MANDATORY BULLETIN No. L 13/042

Effectivity: All L 13 Blanik gliders.

Reason: Inspections carried-out to determine the actual state of those gliders, which are nearing the established third overhaul time limit, result in lengthening the time before overhaul No. 3 depending on instructions outlined in this Bulletin.
The Bulletin contains detailed instructions on the Service Inspection Programme /see item 1/ and established Total Safe Service Life /see item C/.

1

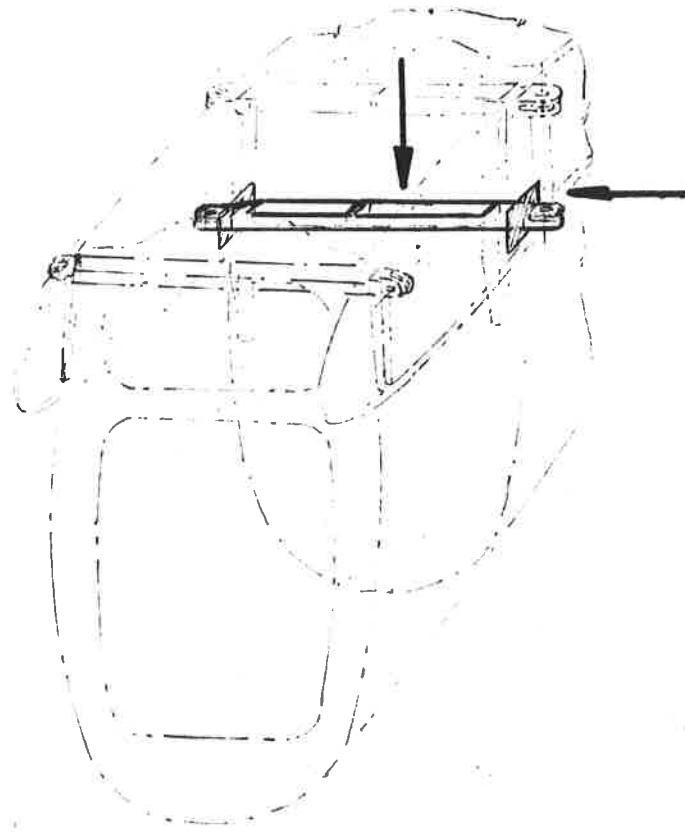
- Check for water leaks into the bottom flangeplate of the centre-section spar /see Fig.1/. Remove all moisture, if any, check for signs of corrosion and remove any corrosion from attacked surfaces using an emery cloth. Apply a protective coating afterwards. A gap between the rib and attachment fitting on the side of fuselage to be covered by an aviation fabric attached by an adhesive.

2

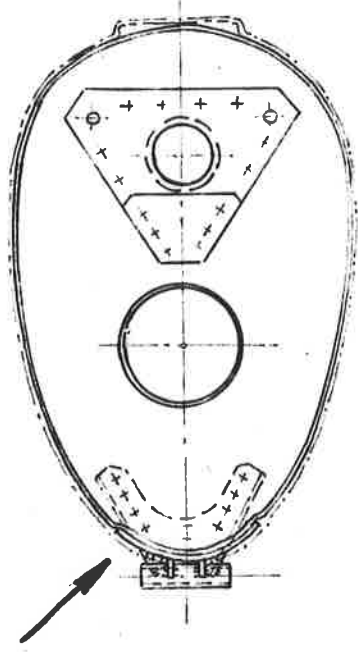
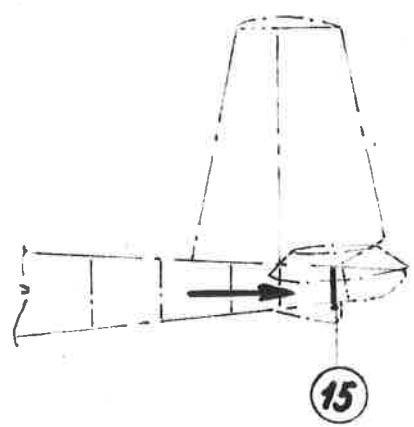
- Check the fuselage frame No. 15 for possible cracking within the tail skid mounting structure /see Fig. 2/. The aircraft is air worthy even in case of two cracks of 10 mm length max. in the bottom frame structure where the tail skid is attached. Ends of such cracks must be drilled off using a drill of 2.1mm dia. Should the length of these cracks exceed the above limit, the frame is to be replaced. Replacement of the fuselage frame is required also in case there are more than two cracks found in the structure.

3

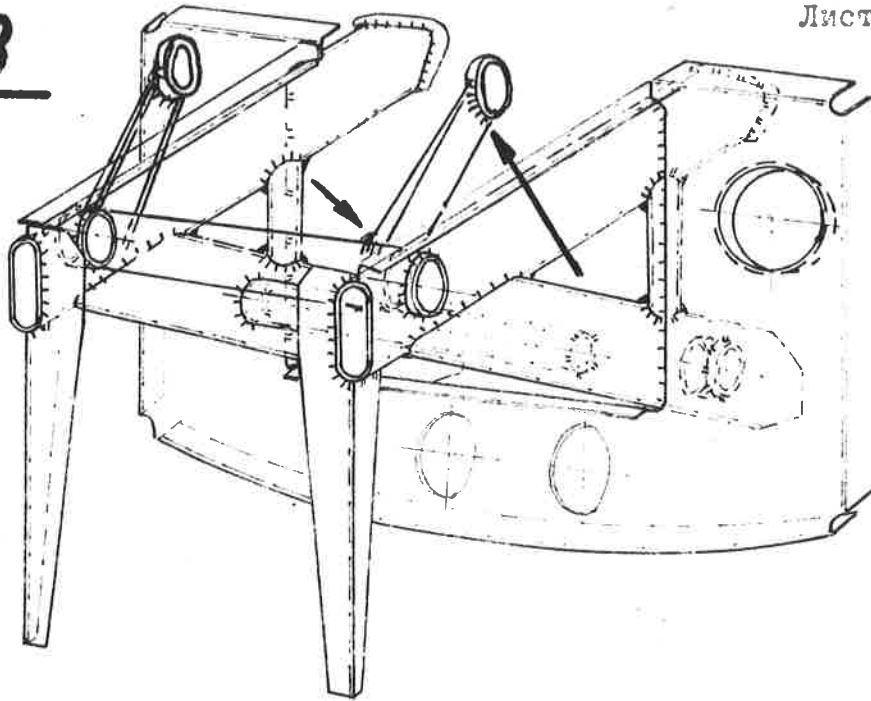
- Check for damage and security of the tail skid rubber silencer. Replace partially cracked silencer if necessary.
- Check the undercarriage silencer mounts and the undercarriage mounting structure /support/ /refer to Fig. 3/ for cracks. Check all welded areas for cracks and replace any damaged parts.

4

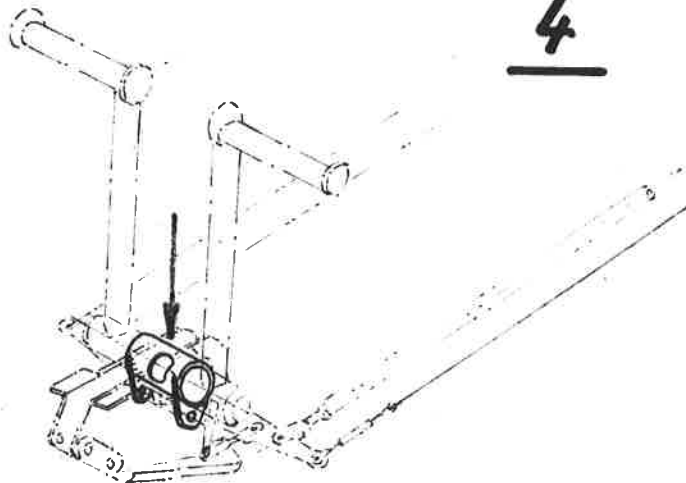
- Check the front pedal controls rocker lever for cracks /Fig.4/. Replace in case this check has revealed any crack. Check for clearance at the end of the foot pedal and use two extreme limit settings of the pedal travel only if the clearance exceeds 2 mm.
- Check for proper clearance of the rudder pedal controls. If the end clearance of pedal when forced sideways exceeds 1 mm, replace its support structure.
- Check the elevator drive for cracks /see Fig.5/. Replace the drive in case any crack is found.

6

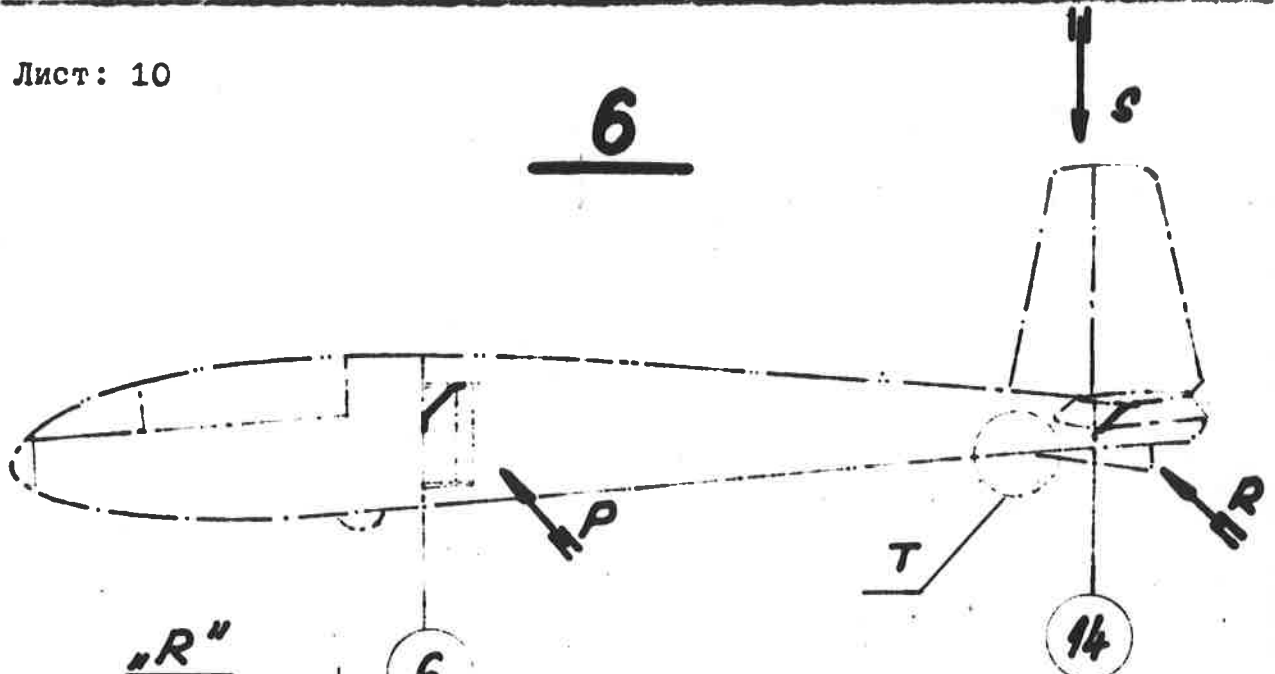
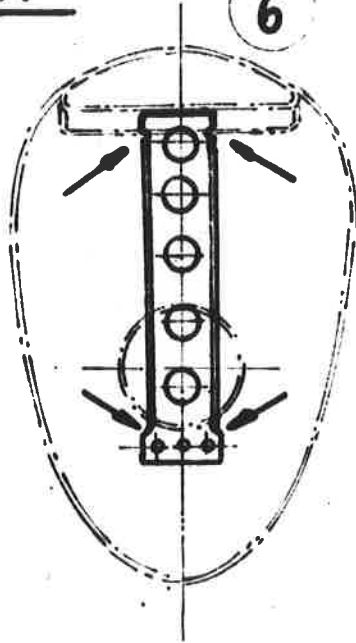
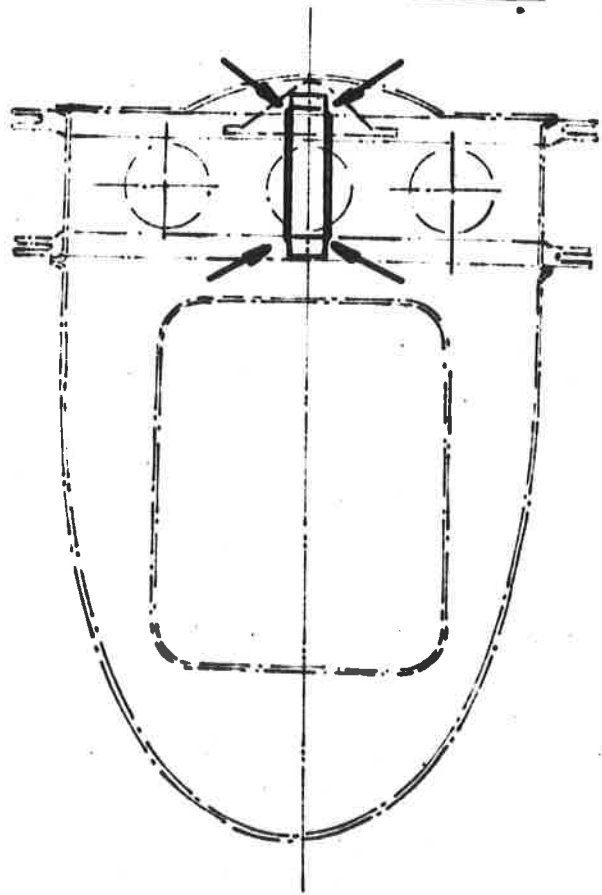
- Check the stiffeners according to Fig. 6 for cracks within the area designated by an arrow. Cracked stiffeners shall be replaced.
- Check for safety of the front tail skid attachment. Should the mount be damaged, replace it for a new one SK-L 13.165 and strengthen its attachment structure on either side of fuselage using a sheet panel of .8 mm thickness and about 50x100 mm size, made from a material designated D 16 T /see Fig. 7, detail view "T"/.

7

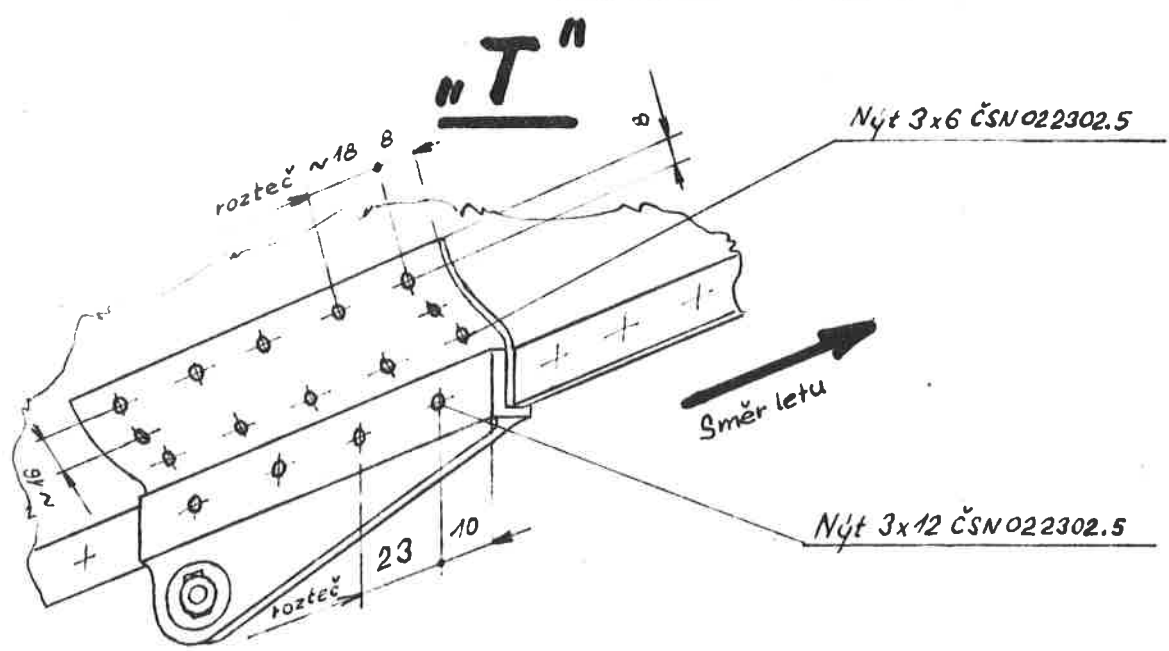
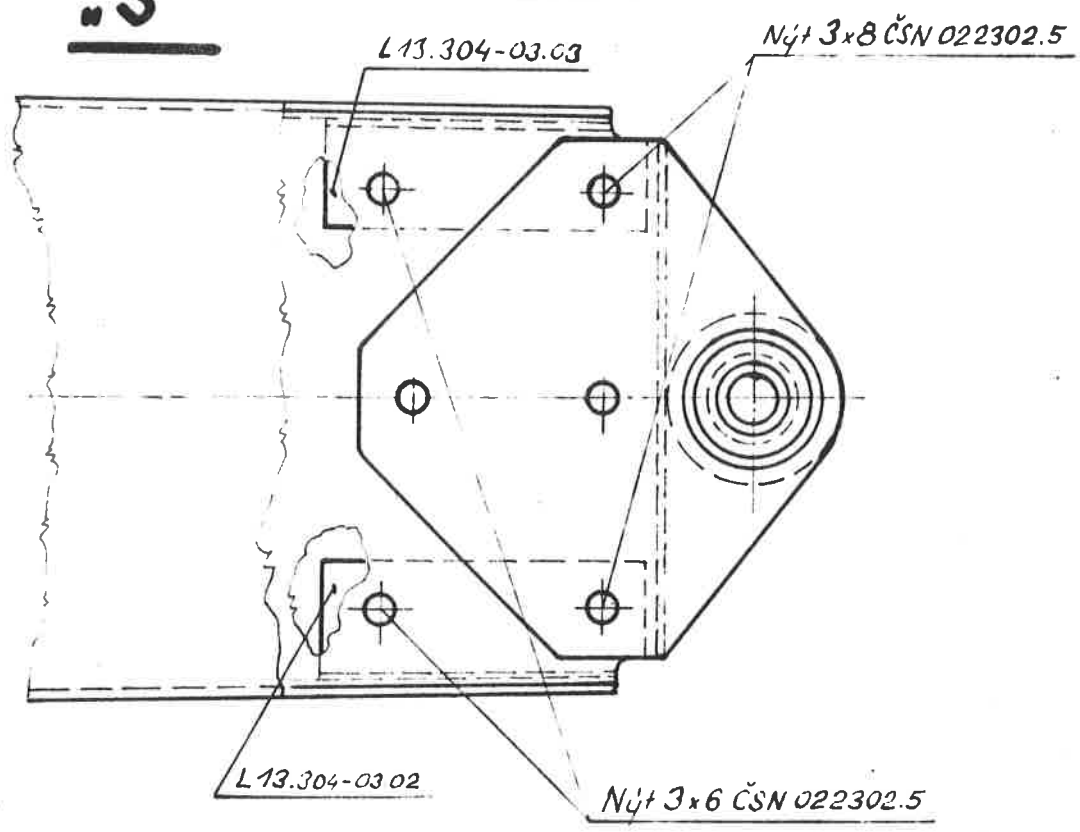
- Check for proper attachment of the top rudder mount on the topmost fin rib and its surrounding area for cracks. Reinforce the area by angle pieces if any crack are found. Refer to angle piece No. L13.304-03.02 /see Fig. 7, view "S"/
-03.03

8

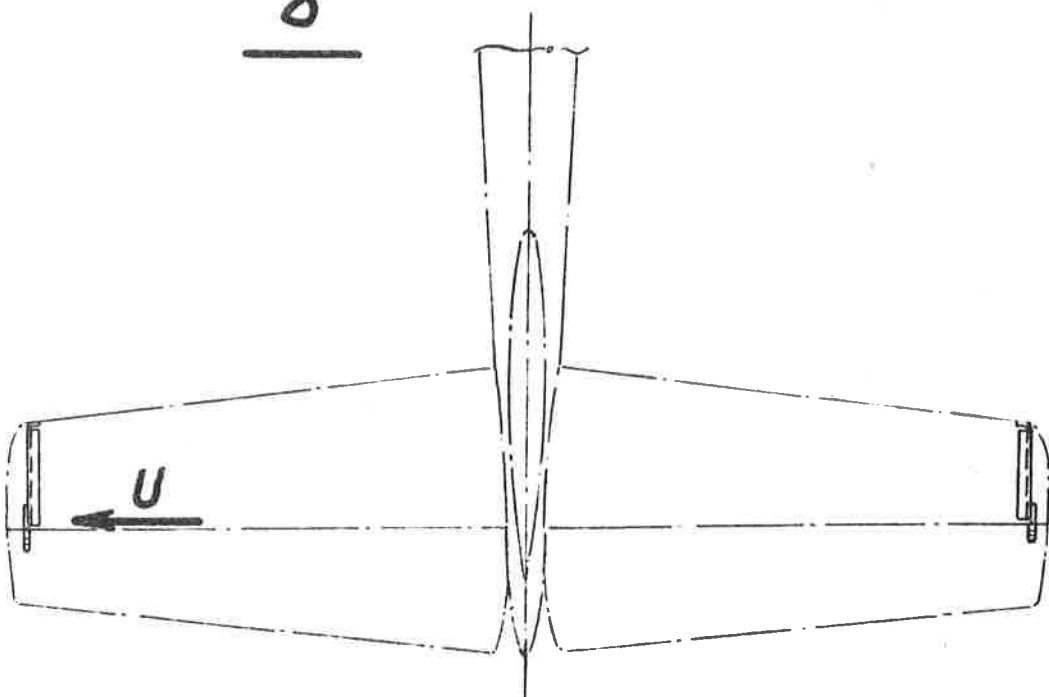
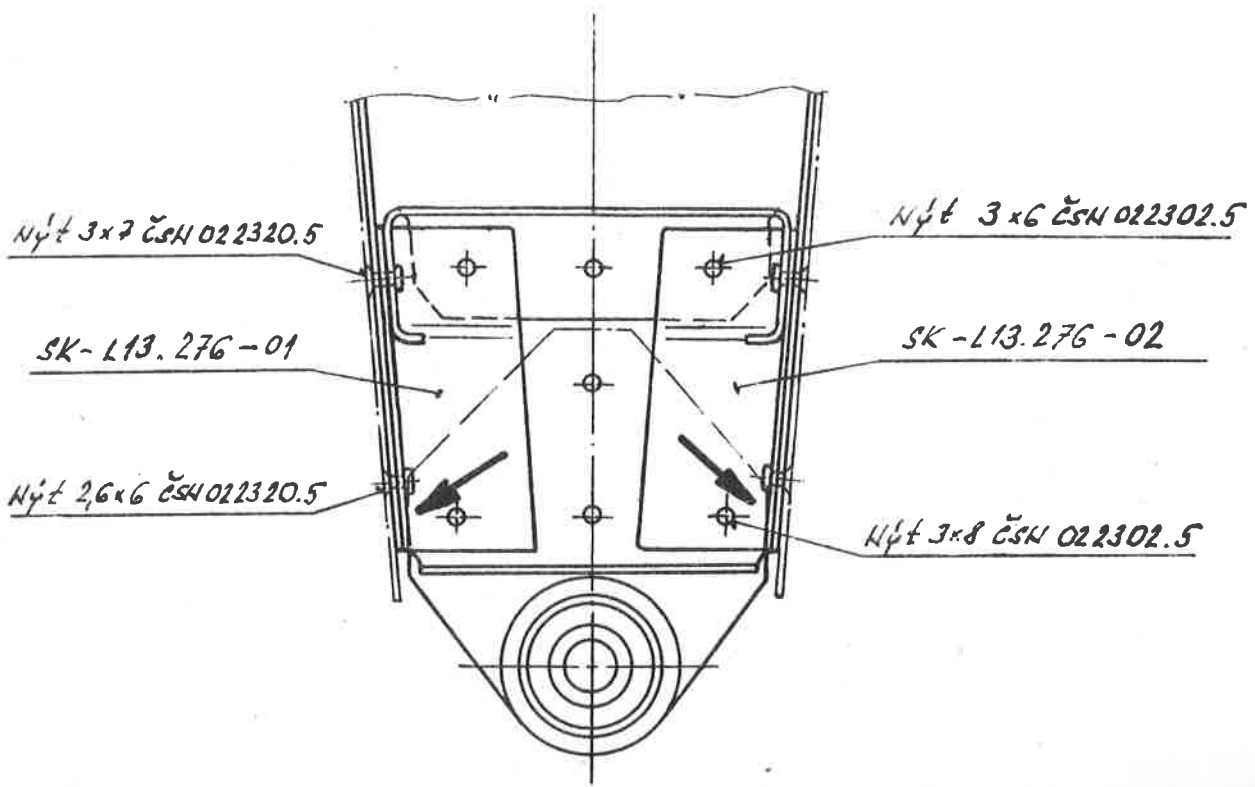
- Check of the elevator edge rib radii for cracks /see Fig. 8/. In case any cracks are found, drill off their ends using a drill dia. 2.1mm and stiffen the ribs by angle pieces SK-L 13.276-02 /see Fig. 8, view "U"/and SK-L 13.276-01.

SK-L13.276-01

SK-L13.276-02

9.

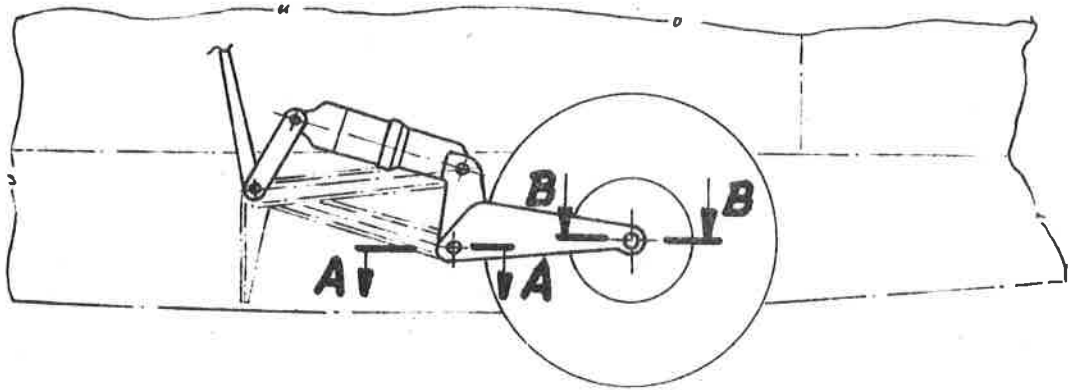
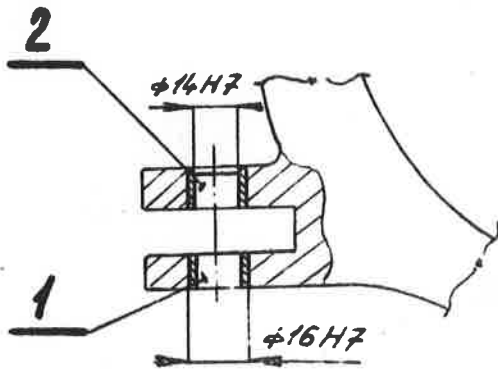
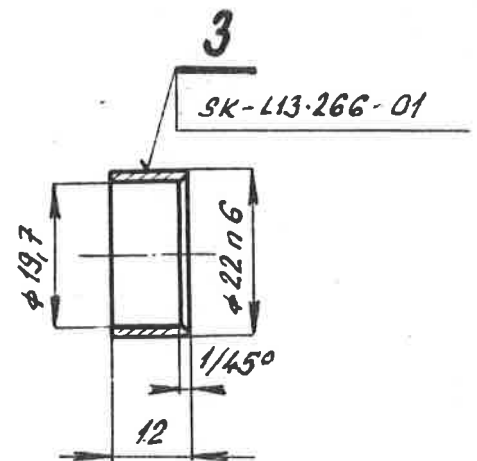
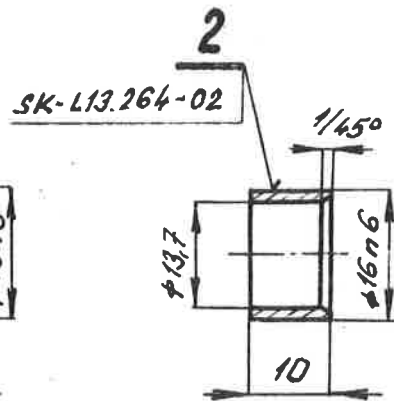
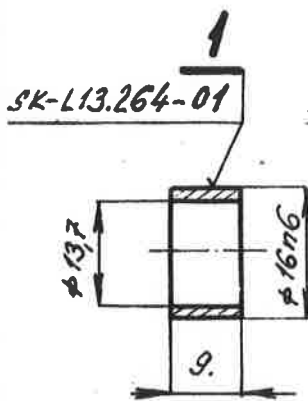
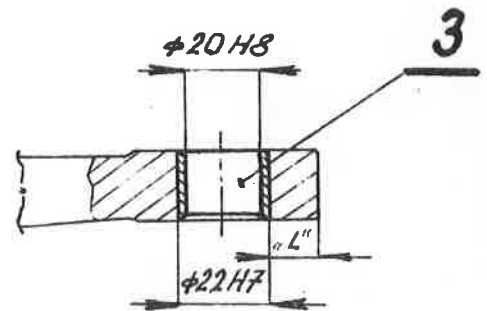
- Check for proper clearances of the undercarriage fork /Fig. 9/. The holes and bolts are of the following size:

Refer to section A-A - the hole dia. in fork: 14H7
dia. of bolt: 14f8

Refer to section B-B - the hole dia. in fork: 20H8
dia. of bolt: 20f8

I. Section A-A

- 1) Reream the holes in fork and support to 14.1H7 dia. or 14.2H7. Install new bolts into the reamed holes. Refer to T.P.G.O./013-058 (dia. 14.1f8) or to T.P.G.O./013-059 (dia. 14.2f8).
- 2) In case of larger clearances ream the holes in fork to 16H7 dia. and press in the bronze bushing (refer to mat. 423016.31). After the bushing has been pressed in, ream the hole to 14H7 dia. The bushings can be manufactured in accordance with Fig. 9 or ordered at the manufacturer according to Dwg.No. specified next to the item. Damaged bolts to be replaced for new ones of the same type.

II. Section B-B

Ream the holes in fork to 22H7 dia., keeping the edge distance, "L", .7 mm min. Press in the bronze bushings, item 3 and replace the bolt for a new one if damaged.
